To: Town Council, meeting March 3, 2020
Re: 15365 Santella Court, S-18-052
From: Dave Weissman

I write in regard to my appeal of the project at the above address, focusing on the building elevation of this proposed house and the Town's recently revised Visibility Analysis Methodology. Per Los Gatos Town codes, if more than 24.5% of a building elevation is visible from a designated Town viewing area, then the house's height is limited to 18 feet.

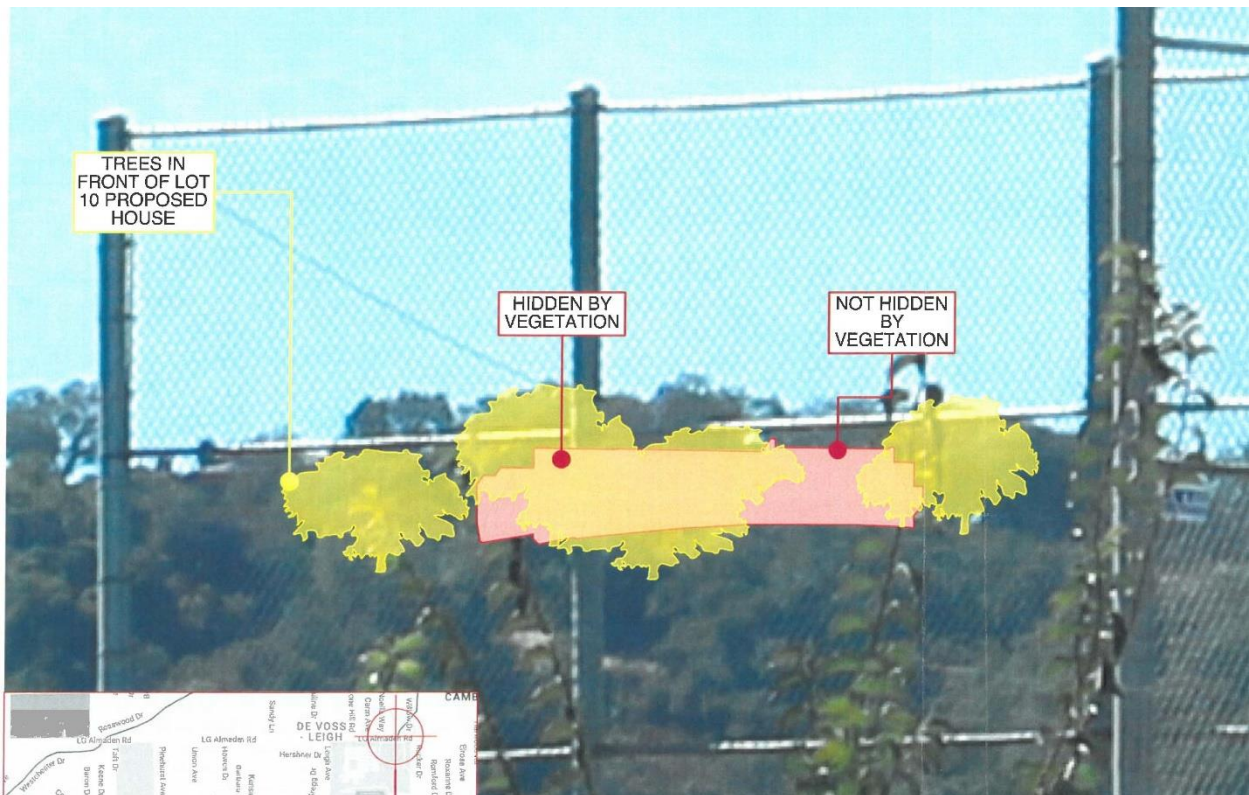
Staff supplied the applicant with an example of an elevation Visibility Analysis (see Figure 1) that was recently done on the adjacent Lot 10 house. Note the pink rectangular section in Fig. 1 – that is the building elevation of the proposed Lot 10 house from the same Viewing Platform that was used for the A&S application before you.

For the proposed house on Lot 10 in Figure 1, the relevant numbers were:

Visible Area: 606.6 SF

Total Area: 2,306.7 SF

This yields a value of 24.2% ($606.6 \div 2306.7$) SF Visible.

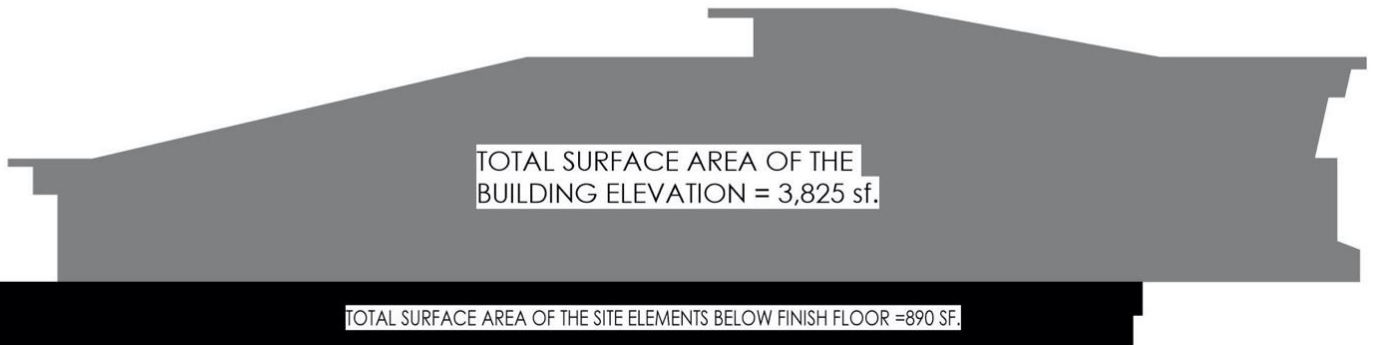
But the new information (see Figure 2), submitted by the applicant after the Commission meeting, shows that of the claimed 3,825 SF total building elevation area, only 2,935 SF are part of the 2-dimensional vertical surface of the proposed house. The remaining 890 SF are actually “site elements below finish floor.” The elevation of the proposed house is 2,935 SF, not 3,825 SF. As the applicant says in his justification letter of February 4th: “We then calculated the surface area of the building elevation *and all connected mass in front of the building (including site elements such as the outdoor seating area in front of the building).*” (my emphasis).

Using these corrected numbers:

Visible Area: 917 SF

Total Area: 2,935 SF

This yields a value of 31.24% ($917 \div 2935$) SF Visible, not 23.97% as claimed by the applicant. Therefore, this house should be limited to 18’ in height since it is above the threshold of 24.5%.

In that same letter of February 4th, the applicant continues “As shown for project at lot #10, we show all the building mass area that would be visible from the viewpoint. This logically includes the mass of the outdoor seating area, in front of the building and **all site elements** (applicant’s emphasis). In a similar scenario, a project with a large visible area of site elements, should be included, to give an accurate calculation of visible home.”

Previous building conventions and community standards, including those applied to adjacent Lot 10, do not include ‘site elements’ when calculating building elevation area. The applicant proposes that his standard be the new Town standard going forward. It is my understanding that the Town Council and staff are given the responsibility of making Town policy, not project applicants.
